**MELBOURN PARISH COUNCIL RESPONSE TO THE UPDATED TRANSPORT ASSESSMENT FOR
S/2791/14/OL LAND TO THE EAST OF NEW ROAD MELBOURN**

Melbourn Parish Council (MPC) has considered Richard Jackson's revised Transport Assessment (Project No: 44687 – Rev A) with particular focus on the Development Impact Assessment (Main Report) and Travel Plan Frameworks (Appendix G).

MAP SHOWING THE NEW ROAD-STATION ROAD AXIS

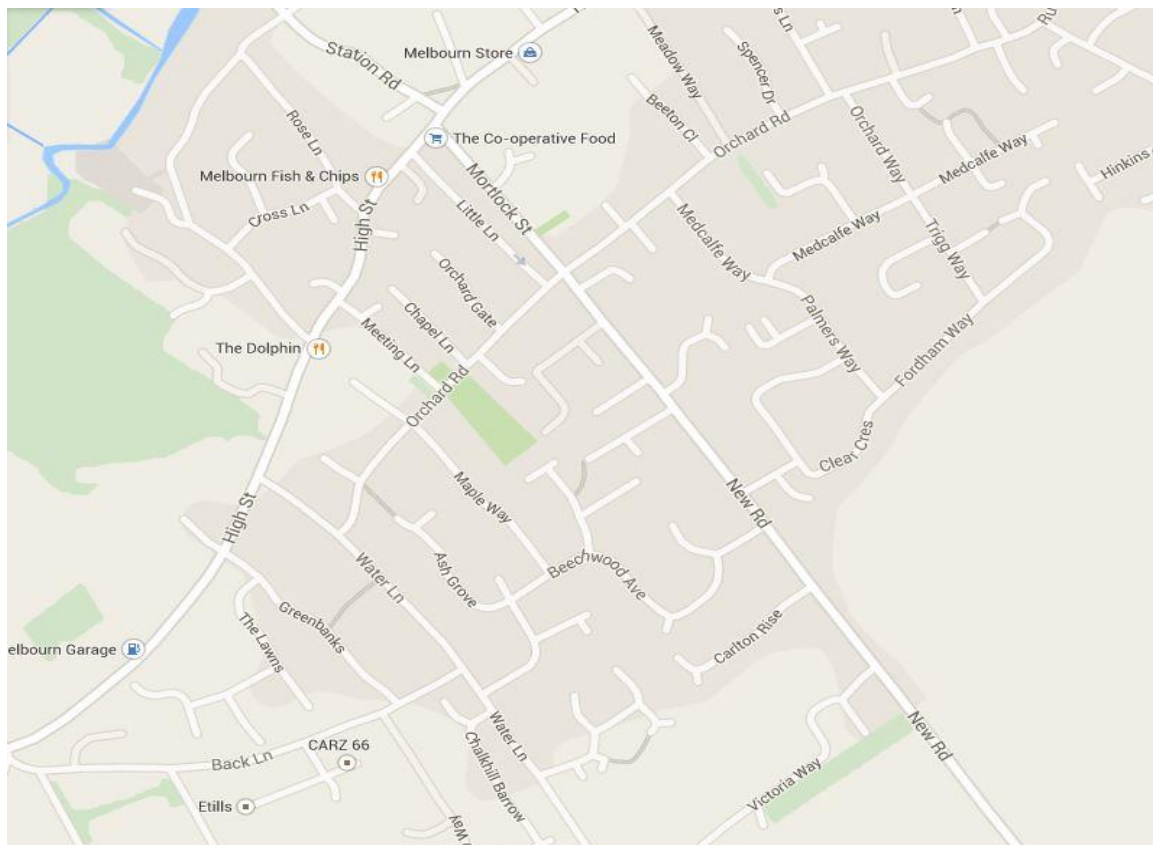
1. The route from New Road through the centre of Melbourn to Station Road and onwards to Meldreth is key to the effective functioning of daily life in the village. This route is used as a cut-through between the A505 to the south and the A10 to the north. The primary school is situated on Mortlock Street to the south of the traffic lights. The GP surgery lies off New Road. There are a veterinary surgery and hairdressers on Mortlock street between the school and The Cross. There is also a dentistry practice adjacent to the primary school in Orchard Road. Children catch their school buses outside the church at The Cross and anyone wishing to catch a train from Meldreth Station travels along Station Road via The Cross.

2. The village shops cluster within 190m to each side along the High Street, which meets the New Road-Station Road axis at The Cross. The shops have regular deliveries and there is no room for lorries to pull off the road (see photo on page 9). The butcher's shop retains its own abattoir and the waste lorry has to park on the High Street, immediately opposite the Co-op, to empty the abattoir's tanks. The main bus stops to Royston and Cambridge, the village car park and the village community centre also lie along the High Street within 190m to the east.

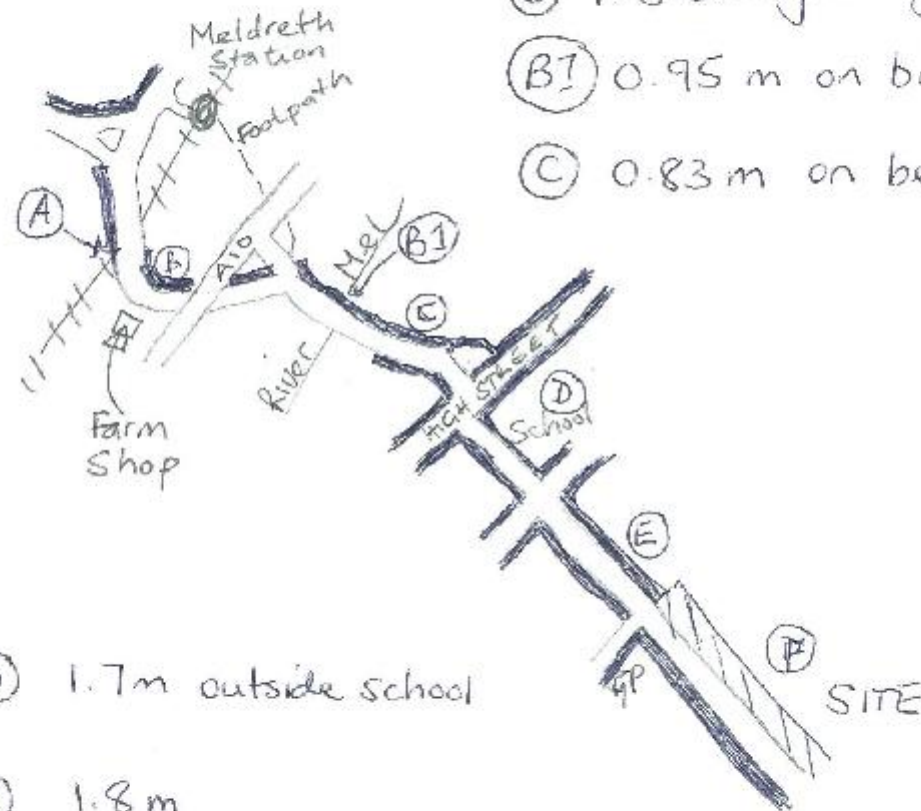
- b. The return journey from the station will be potentially more dangerous than the journey to it. The crossing point over the road at the foot of the bridge near Valley Farms entrance has barely 40m visibility to see oncoming traffic coming from Melbourn direction, due to a vent pipe from the sewers and a telegraph pole, plus vegetation. Cars here are travelling quite fast and don't expect to see pedestrians. There is of course the added issue of commercial vehicles entering and leaving the farm complex.

- No wheelchair user could safely use the route,
- No motorised mobility scooter could fit on the footpath safely
- No infirm person could walk the route,
- No vision impaired person could use the route
- No parent with a small walking child could use the route safely,
- No parent with a buggy / pram could navigate the footpath over the bridge let alone cross the roads so many times safely.
- Able bodied users without any children still have to step into the road to pass each other, again very dangerous.

In short this route is totally unacceptable in its current form and again Melbourn Parish Council rejects the developer's claims of sustainability. The clear and only actions if planning permission is to be considered are:

- To widen the footpaths from the proposed development to both the station routes, making them all DDA compliant. Cycle path allocation should be provided to allow the free movement of traffic and cycles without coming into conflict with each other. This is very difficult to achieve in practice
- Street lighting must be provided along the whole route to afford security to pedestrian users.
- All existing crossing points at the traffic lights should remain with the plan to add the fourth crossing point in Station Road.
